FIVE ESTUARIES OFFSHORE WIND FARM

10.20.1 TECHNICAL NOTE: METHODOLOGY FOR DETERMINING MDS (OFFSHORE) – REVISION C (CLEAN)

Application Reference:	EN010115
Application Document Number:	10.20.1
Revision:	C
Pursuant to:	Deadline 6
EcoDoc Number:	005395492-05
Date:	February 2025

Figure 1 Offshore cable crossings

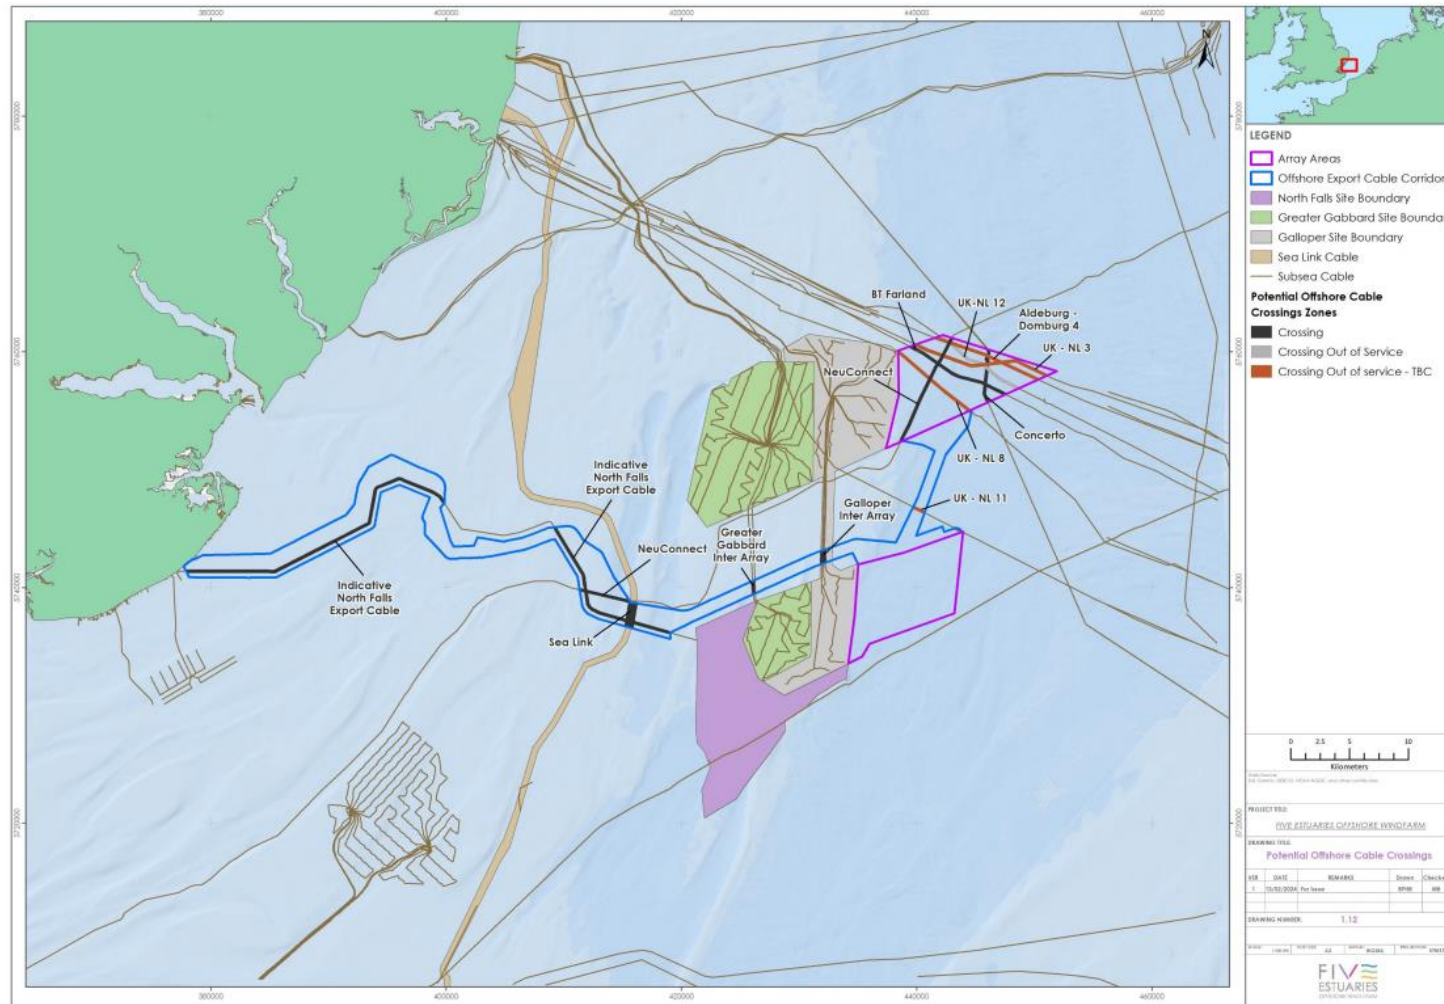
b) Paragraph 2.1.3 restates that the maximum number of cable crossings has been set at 56. The Applicant must present a detailed explanation of how this parameter has been established, including any assumptions made.	Further details are provided in Section 2.1.

2.1.4 Figure 1 has been extracted from the Offshore Project Description [APP-069](#). It can be seen that there are a number of planned, active, inactive / out of service cables in the Export and Array area. This has been further summarized in Table 2.

- 2.1.5 The project has allowance for 56 cable crossings. At least 14 of these are anticipated to be for the export cables in the Export Cable Corridor (ECC). This leaves 42 for the array areas. It is not possible to identify the number of crossings in the array area until the final layout and array routing has occurred, and this will not be done until after DCO award. Similarly there are a number of OoS cables where though it is assumed the preference is to but remove these, however this is not confirmed yet. This is why the project cannot confirm the total number of crossings and instead has to make an allowance based on a range of possible scenarios.

Figure 5 Assumed external protection trapezium. Please note that bottom width is stated as 9.7m as it has been rounded to 1 decimal place

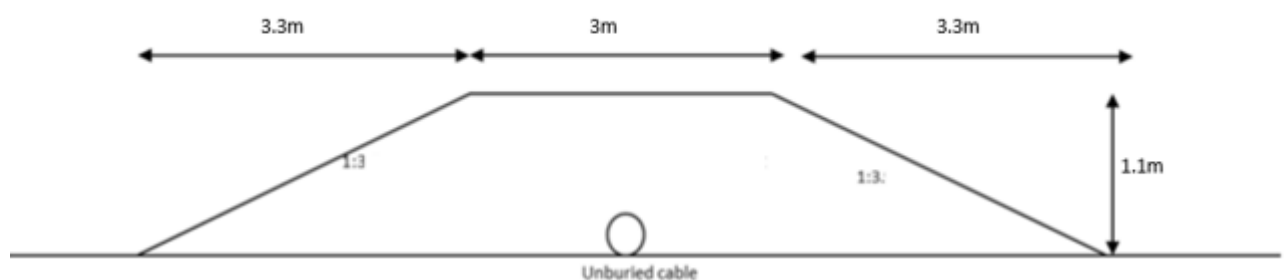
c) Paragraph 2.2.2 refers to the potential for a very small volume of sediment being trapped within rock voids and/or accumulating on the updrift side of berms of the cable protection, if required. The Applicant is requested to quantify the volume or provide an estimate of the maximum expected volume of such sediment.	An estimate of the volume of trapped sediment has been provided in Section 2.2. Context for this volume is provided in relation to the tip of the Margate and Long Sands (MLS SAC) sand bank which intersects the Export Cable Corridor (ECC). The relative volumes of potential trapped sediment and the tiny proportion of the nearby sandbank demonstrate that the potential effect of the project is not material.

2.2.3 To calculate the volume of cable protection, the cross sectional area based on the above parameters is calculated, using the equation for the area of a trapezium:

$$6.99 = \frac{3 + 9.7}{2} 1.1$$

2.2.4 The area for the trapezium is therefore calculated as 7m² which can then be multiplied by the length of cable protection to provide the volume.

Figure 8 Historic bathymetry of the M&LS shown on marine charts

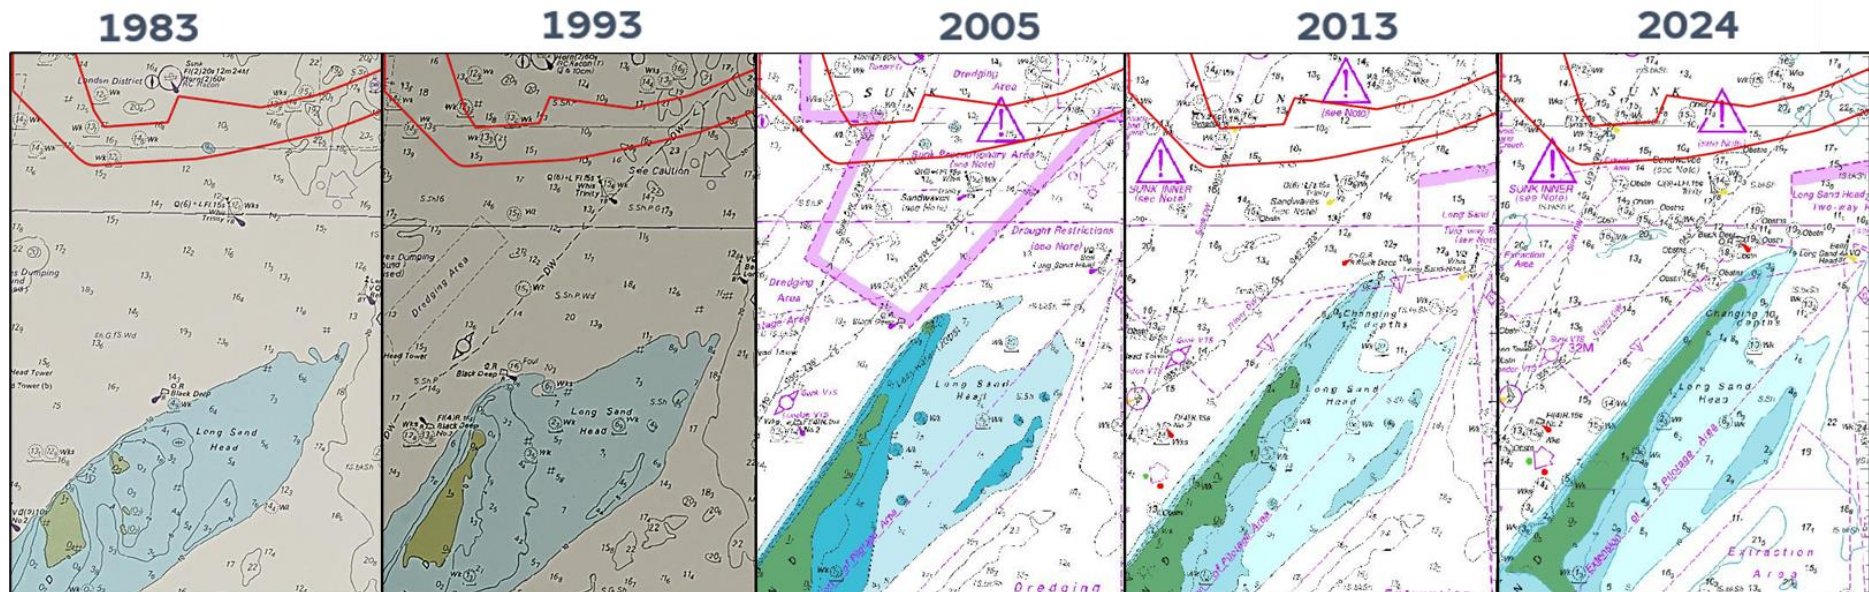
d) Paragraph 2.2.4 states that monitoring and observation of operational offshore wind farms shows that large scale morphological features are not affected by the presence of assets (cable protection) and that scour impacts would be very small. The Applicant is requested to ExQ2	Covered in section 2.2.9 and 2.2.12.

2.2.10 To support the assertion that the sand bank is controlled by processes that are orders of magnitude larger than the maximum impact of the project, the Applicant refers to the historic movement of the sand bank shown in Figure 8 below.

2.2.11 The volume involved in this movement are in the order of magnitude of hundreds of millions of m^3 of sand each decade.

2.2.12 The Applicant maintains the worst case installation of cable protection in the ECC and array areas combined are many orders of magnitude too small to impact either the M&LS sand bank or the wider sediment transport processes in the area.

Figure 9 Sediment dispersal during jetting (IMCA Code of Practice for Offshore Cable Laying in the Renewable Energy Industry M264 Rev. 0.1 – November 2023)

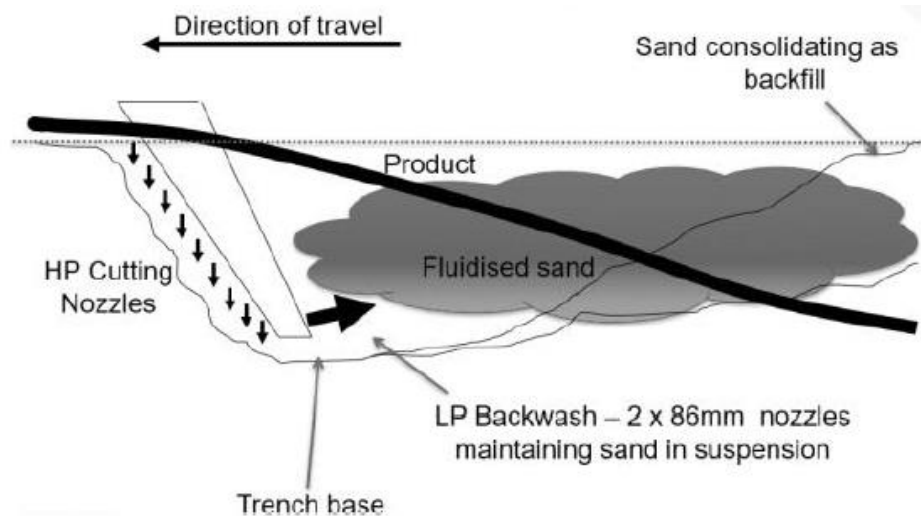
Responses by Deadline 4 (3 December 2024) Page 13 of 29 Question to: Question submit evidence in support of this	
e) Paragraph 2.4.2 states that a 50% assumption has been applied to sediment disturbed from fluidised material dispersed during cable trenching. This information seems to contradict the Applicant's response at Deadline 1 [REP1-051] that an assumption of 100% of material is fluidised and displaced. The Applicant is requested to clarify what has been considered in the assessment. The ExA notes that Table 2.8 in [APP-071] states that a sensitivity check on 100% of material ejected in local areas was undertaken. The Applicant is requested to confirm where this is presented in the Application documentation.	Further explanation is provided in Section 2.5.

- 2.5.2 The total volume values in this table are estimated with a 50% assumption, regarding the amount of sediment disturbed. This value was used because in most cases during simultaneous cable lay and bury activities, less than 100% of the material from within the trench profile is expected to be ejected into the water column. An example of this for jetting is shown in the sketch in Figure 9. Whilst some of the fluidised seabed sediment is ejected into the water column and may disperse as a plume, a large proportion (maximised by design) is also deliberately retained within the trench to provide immediate backfill over the cable.

- 2.5.4 We note that the maximum total volume values in the table are the same if calculated either using a typical average burial depth of 1.75 m and a 100% ejection assumption, or, if using the maximum burial depth of 3.5 m and a 50% ejection assumption. These values provide a realistic worst-case scenario for sediment disturbance associated with cable laying.

Figure 10 Maximum length of cable in SAC

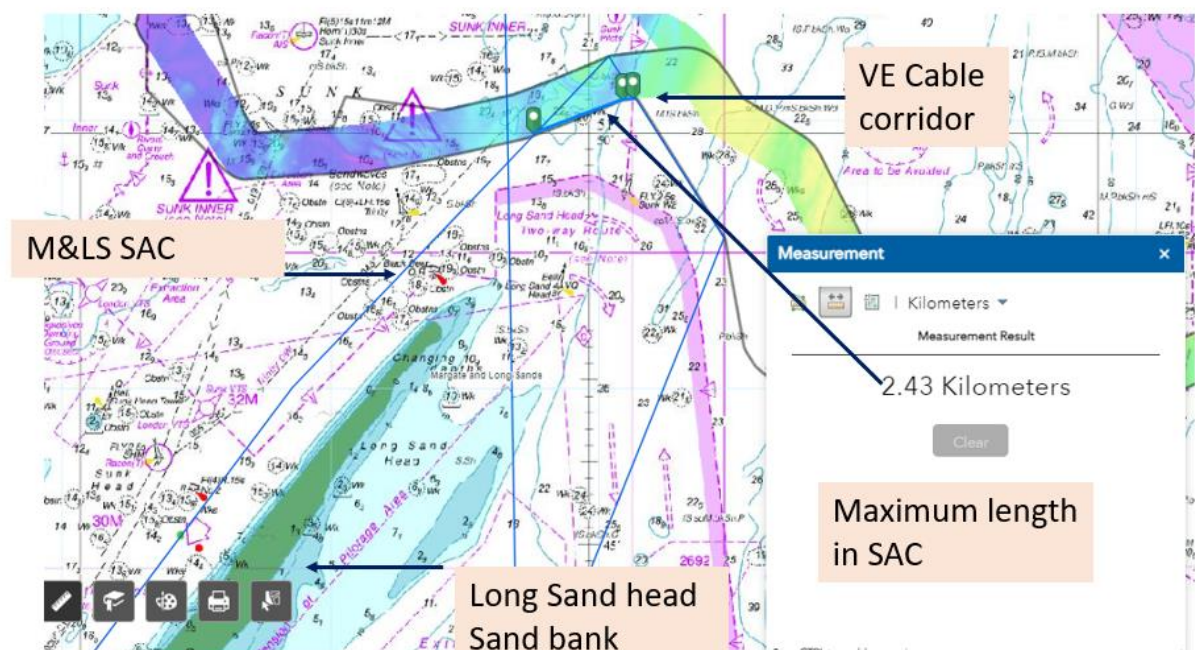
3.1 HOW HAS MAXIMUM LENGTH OF CABLE PROTECTION REQUIRED WITHIN MARGATE AND LONG SANDS (MLS) SPECIAL AREA OF CONSERVATION (SAC) BEEN DETERMINED?

- 3.1.1 Theoretical max single cable length is estimated at circa 2.5 km as shown in Figure below. It can also be seen that the Long Sand Head sand bank feature is 4-5km from the cable corridor and separated by the Long Sand Head two way route (Shipping Lane) used by vessels transiting to the ports.

- 3.1.2 This would be hugging the southern corridor edge. The project cannot conduct the final routing until post DCO, however the Applicant has committed to the following *“Final cable routing will seek to take the shortest route through the M&LS SAC where possible”* (9.13 Margate and Long Sands SAC Benthic Mitigation Plan [APP-243 Table 9.1]).

- 3.1.4 Based on the preliminary work conducted to date this is resulting in indicative routes with between 0.4-1.5km within the SAC.

- 3.1.5 Based on the ground conditions, and variations in potential final route lengths through the M&LS SAC, a total length of 900 m of cable protection (5,400 m² and 5,400 m³) in the SAC has been assumed as the realistic MDS. It could be a combination of lengths up to 900 m and the location of the cables could be anywhere within the offshore ECC corridor. This has been combined with an assumed mattress width of 6 m to result in the 5,400 m². Whilst this value is considered highly conservative by the Applicant and the most likely scenario is that no external cable protection will be used, the assessment has been based on 5,400 m² to allow for a degree of unforeseen ground conditions that may require a small amount of cable protection.
